Record of Executive Business and Chief Executive's Order

PR/1166/21

Reg. Reference: SD21A/0186 **Application Date:** 05-Jul-2021 **Submission Type:** New Application **Registration Date:** 05-Jul-2021

Location: Plot 100, Profile Park, Nangor Road, Clondalkin,

1. "Traffic and Transport Assessment (TTA)

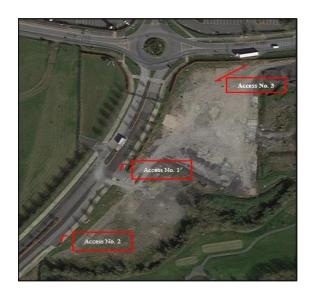
The transportation report demonstrates that the traffic flows associate with the proposed development can safely be accommodated by the local road network.
